ST. TAMMANY PARISH

**Addendum No.:** 2

**Bid#:** 327-00-18-50-2

**Project Name:** Safe Haven Renovations Quad A

TITLE:  
**PARTIAL FLOOR PLAN**  
 SHEET:  
**ASK-01**

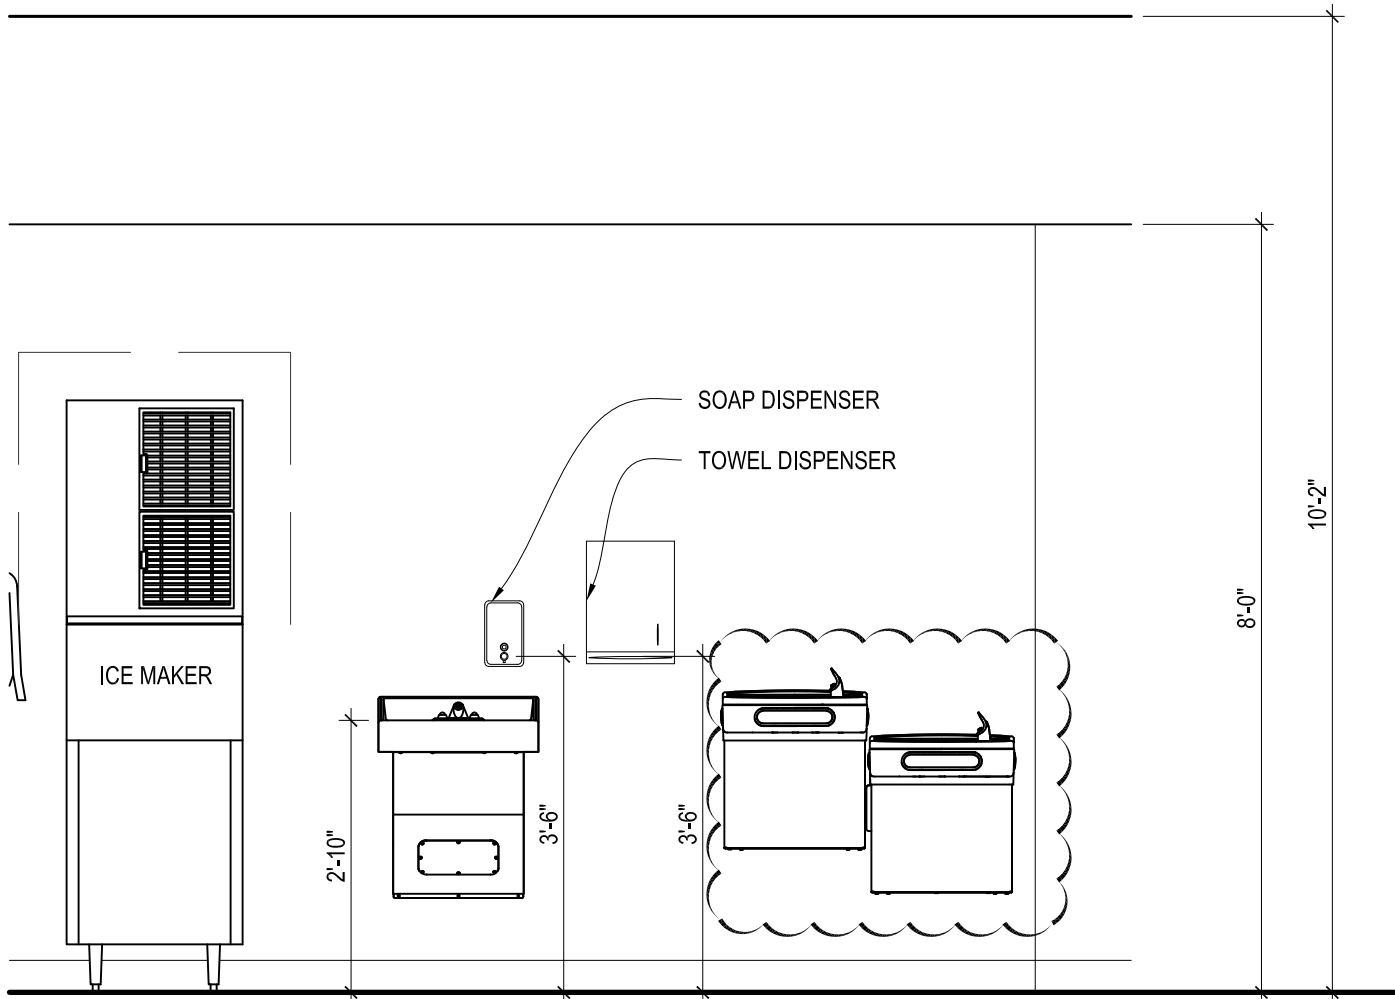
7. At Section 11 – Drawings, sheet A1.02, **ADD** sheet ASK-01 revising detail 1/A1.02 to indicate the location of a water cooler. (Attached)
8. At Section 11 – Drawings, sheet A4.03, **ADD** sheet ASK-02 revising detail 5/A4.03 to indicate the location of a water cooler. (Attached)

TITLE: ROOF DETAILS  
 SHEET: ASK-03

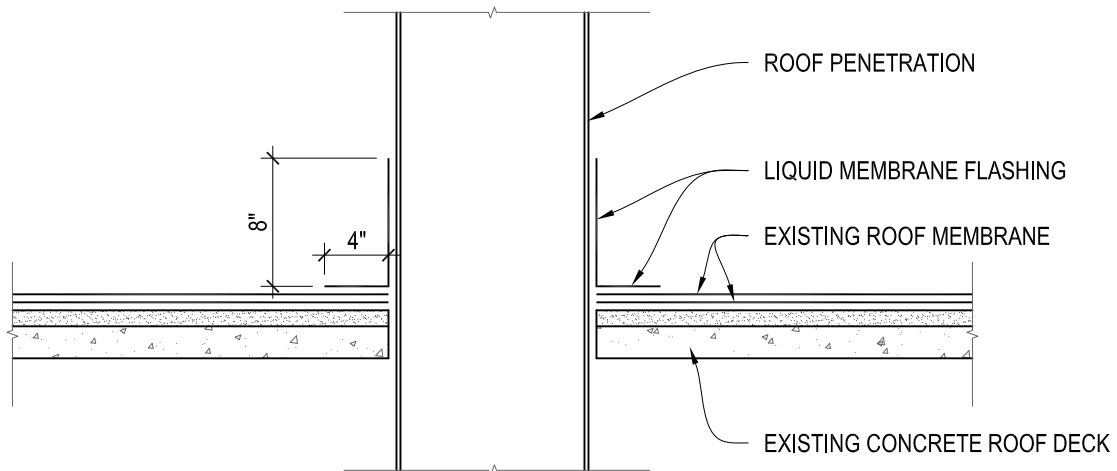
9. At Section 11 – Drawings, **ADD** sheet ASK-03 for roof penetration details. (Attached)
10. At Section 11 – Drawings, sheet ENV-1, **DELETE** Abatement Notes #6 and **ADD** “6. The air monitoring of the project shall be provided through the general contractor from the list as per Specifications Section 02 82 10.”

SHEET:  
**M1.01**

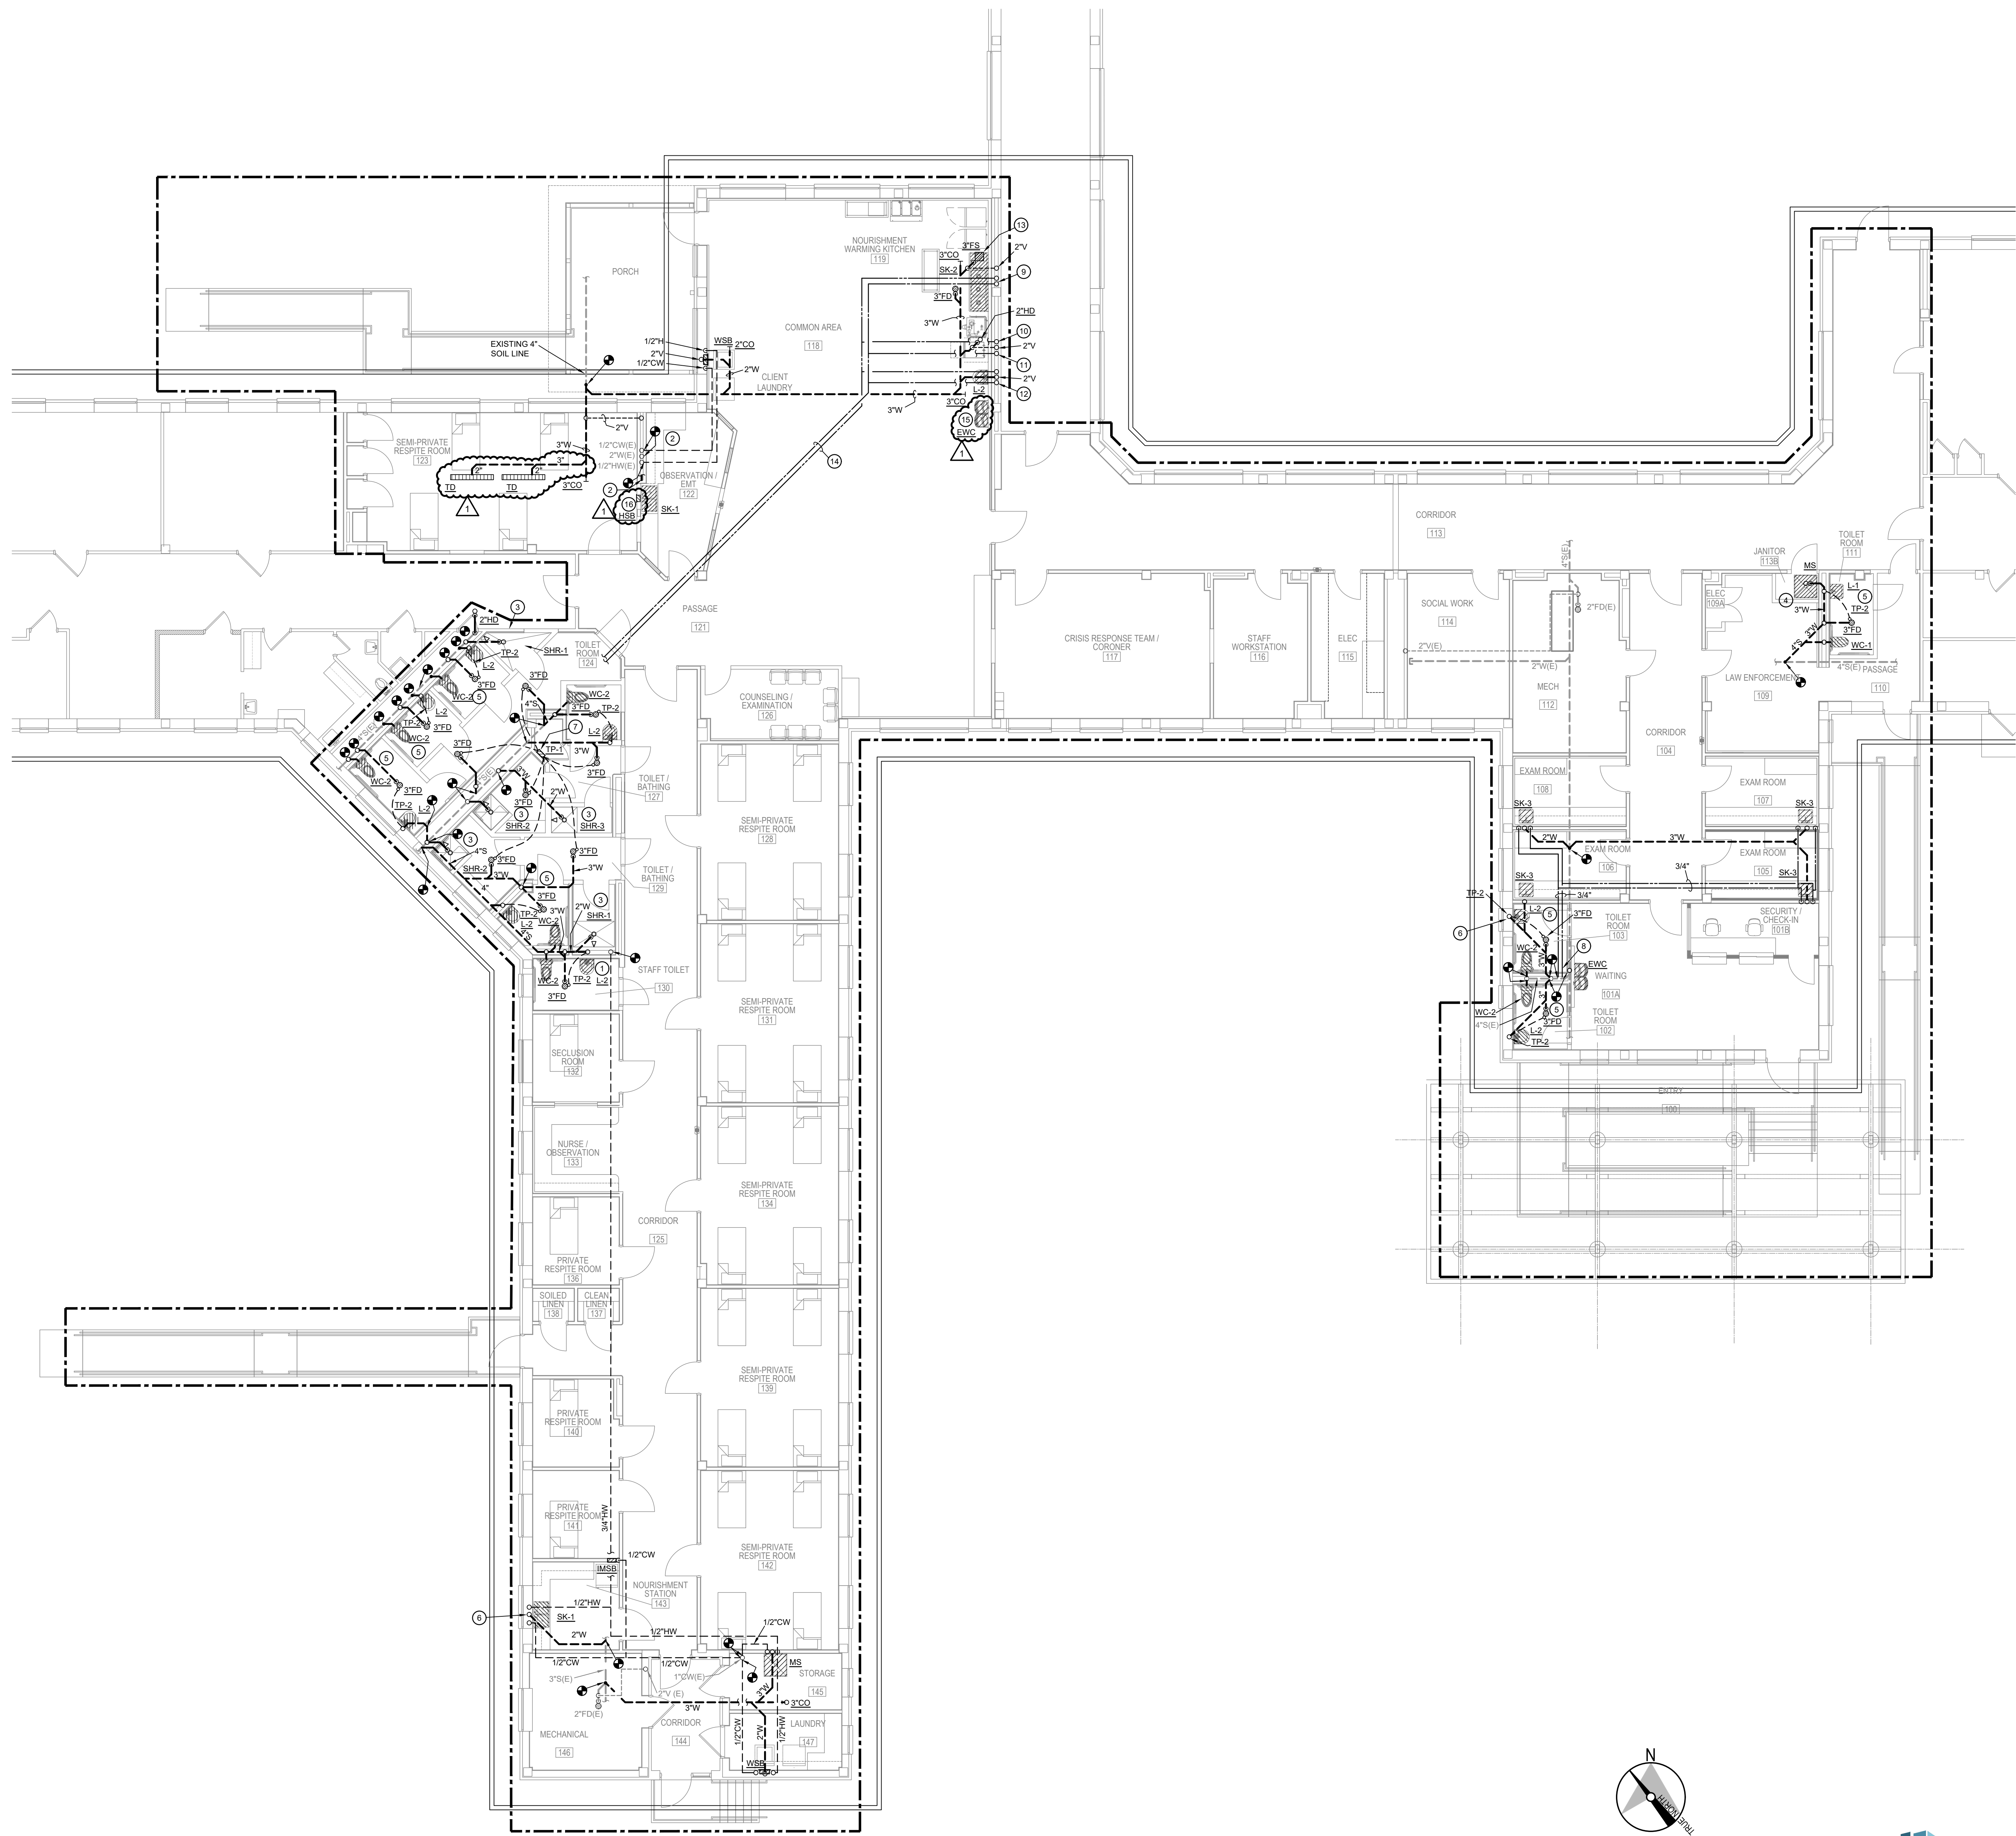
11. At Section 11 – Drawings, **DELETE** sheet M1.01 and **ADD** sheet M1.01 Rev. 1 dated 6 May 2019. Added electric water cooler in 118 – Common Area, added hose bibb and revised trench drains in 123 – Semi-Private Respite Room. (Attached)
